## Product Change Notice (PCN)

**PCN Number:** PCN-0381408R-01

Product(s) Affected: CMS-160916-30-3

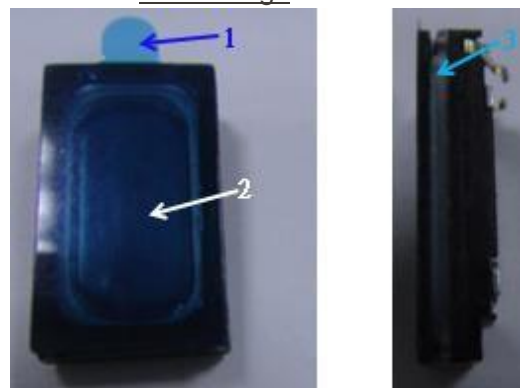
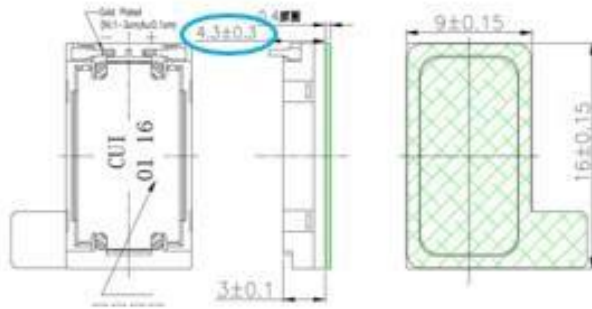
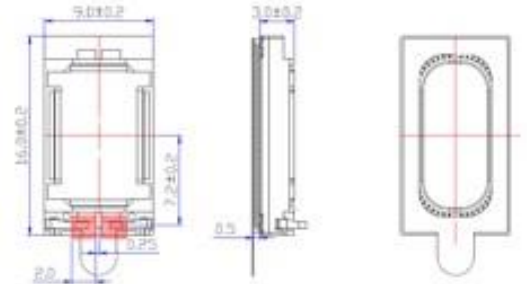
Description of Change: *Power rating change to 0.8W rated; sound pressure level change to 88dB @ 0.8/10cm; resonant frequency change to 600Hz; THD change to 15% max; multiple housing/appearance modifications as shown below:*
